**National Committee on  
Seismic Design Parameters (NCSDP)  
for River Valley Projects**

**MINUTES  
OF  
24<sup>th</sup> MEETING  
(15<sup>th</sup> March, 2013)**

**(Special meeting to discuss the site specific seismic design  
parameters of Subansiri Lower Project,  
Assam-Arunachal Pradesh)**

## **Minutes of the 24<sup>th</sup> Meeting of National Committee on Seismic Design Parameters (NCSDP) for River Valley Projects held on 15<sup>th</sup> March, 2013 in CWC, New Delhi**

**Fig (1) PSHA estimate for MCE**

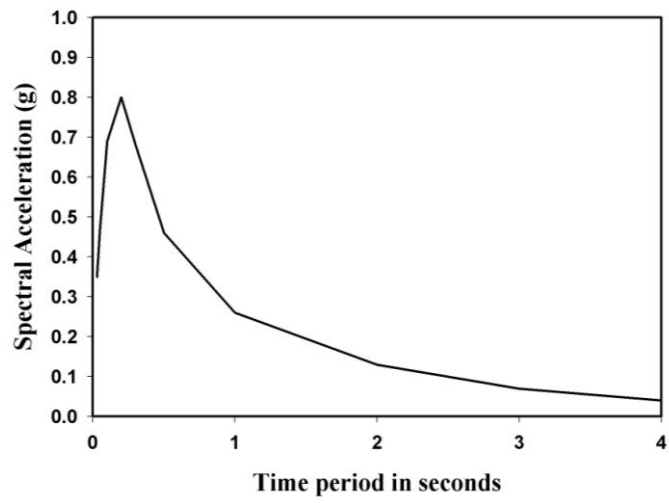
Dr. M.L. Sharma (IITR) informed the Committee that they have now carried out the site specific seismic parameters study by probabilistic approach as well. Making a brief presentation of the spectral acceleration estimation (**Annexure-III**) arrived by IITR using the Probabilistic Seismic Hazard Assessment (PSHA) approach, Dr. Sharma stated that PGA(h) values for both MCE and DBE conditions arrived through PSHA are lower than the earlier approved values arrived through Deterministic Seismic Hazard Assessment (DSHA) approach. He further said that the outcome of 2D seismic reflection survey and Paleoseismological investigations also do not indicate any impact on the earlier agreed parameters, which are on the conservative side.

***In view of above discussion and in light of the outcome of IITR's new seismic parameters study using probabilistic approach, the Committee decided that further revisions in the approved seismic design parameters of SLP (as approved by NCSDP in its 14<sup>th</sup> meeting held on 29-04-2004) may not be required.***
